SUBJECT: ISSUANCE OF AMENDMENT NO. 71 TO FACILITY OPERATING LICENSE NPF-35  
AND AMENDMENT NO. 65 TO FACILITY OPERATING LICENSE NPF-52 - CATAWBA  
NUCLEAR STATION, UNITS 1 AND 2 (TACS 75484/75485)

The amendments revise TS 3.1.3.5, Figure 3.1-1, and Basis 3/4.1.3 to modify the fully withdrawn control rod bank insertion limits from 228 steps to at least 225 steps.

SAFETY EVALUATION BY THE OFFICE OF NUCLEAR REACTOR REGULATION  
RELATED TO AMENDMENT NO. 71 TO FACILITY OPERATING LICENSE NPF-35  
AND AMENDMENT NO. 65 TO FACILITY OPERATING LICENSE NPF-52

FIGURE 3.1-1  
 ROD BANK INSERTION LIMITS VERSUS THERMAL POWER  
 FOUR LOOP OPERATION

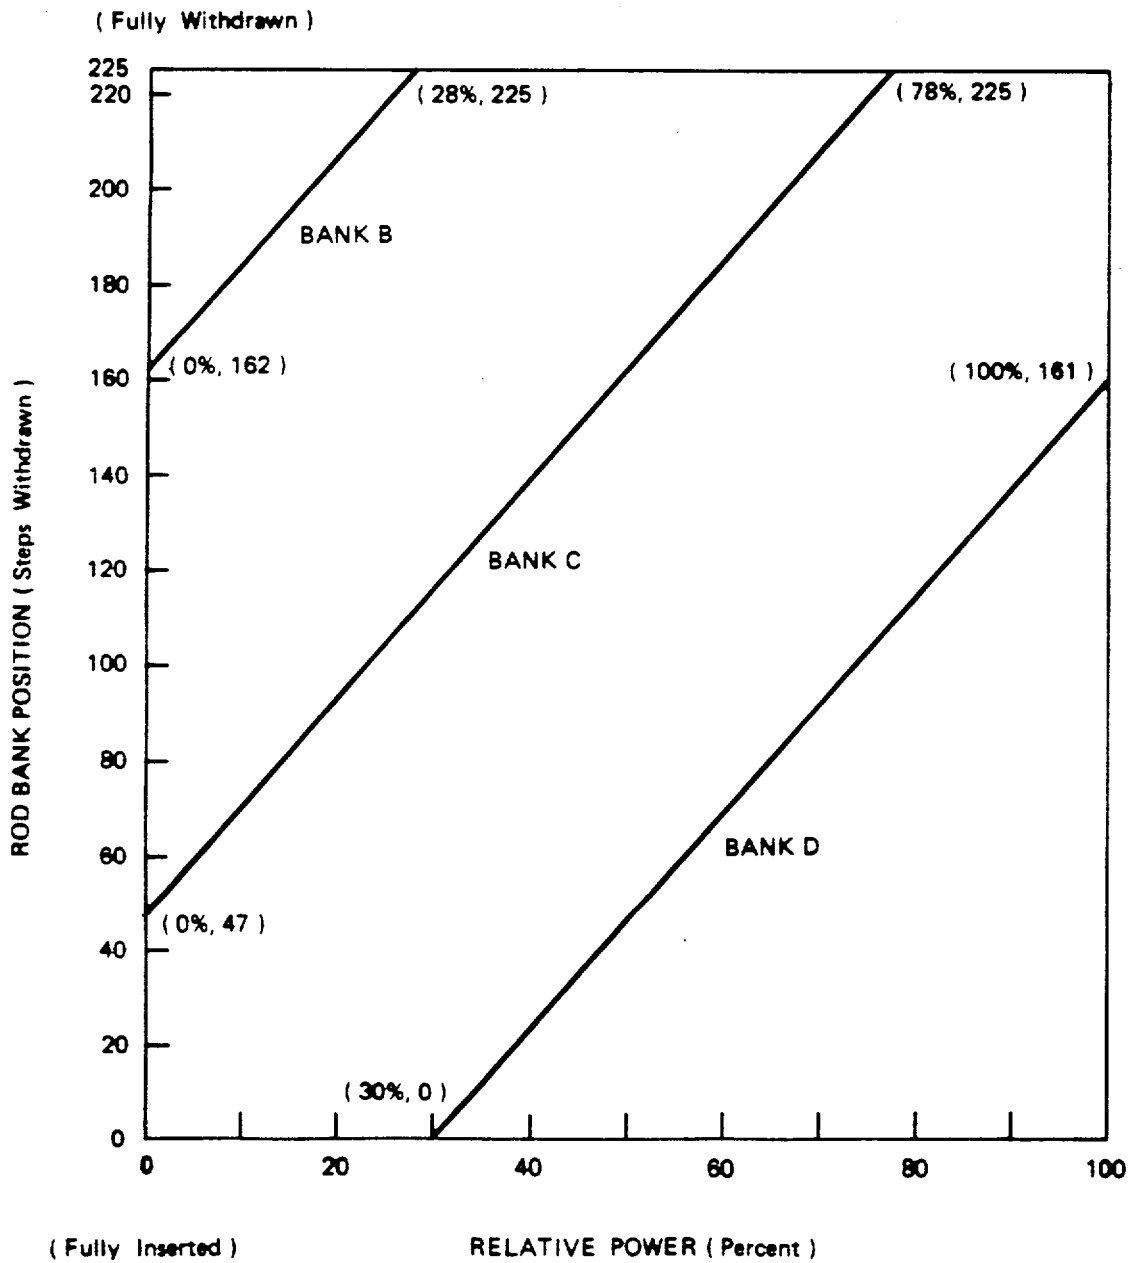
By letter dated November 10, 1989, Duke Power Company, et al. (the licensee), proposed amendments to Catawba Nuclear Station, Units 1 and 2, Technical Specification (TS) 3.1.3.5, "Shutdown Rod Insertion Limit," and Figure 3.1-1, "Rod Bank Insertion Limits versus Thermal Power Four Loop Operation." Specifically, the definition of "fully withdrawn" is changed from "228 steps withdrawn" to "at least 225 steps withdrawn." Additionally, TS Basis 3/4.1.3 is revised to provide justification for the TS change.

The licensee's analysis of the proposed TS change indicates that its impact on key safety parameters is negligible and bounded by the Final Safety Analysis Report (FSAR) accident analyses. The slight increase in rod drop time (0.018 seconds) at the "230 step fully withdrawn" position is accommodated by the available margin (1.8 seconds). Also, sufficient excess shutdown margin exists to compensate for the approximately 30 pcm decrease at the "225 steps fully withdrawn" position. The maximum positive reactivity insertion rate resulting from an uncontrolled RCCA bank withdrawal from a subcritical or low power startup condition, as well as at power, is negligibly changed by the proposed TS revision and remains bounded by the accident analyses. RCCA ejection accidents at the "225 step or greater fully withdrawn" position are also bounded by existing analyses. In addition, the revised axial power distribution resulting from the proposed change is accommodated by the available

peaking factor margin and remains within the established TS limits. At the "225 steps fully withdrawn" position, a maximum decrease of 50 pcm in trip reactivity worth results from the proposed change. To compensate for this slight decrease, the licensee has stated that a 75 pcm penalty will be considered in all trip reactivity calculations.
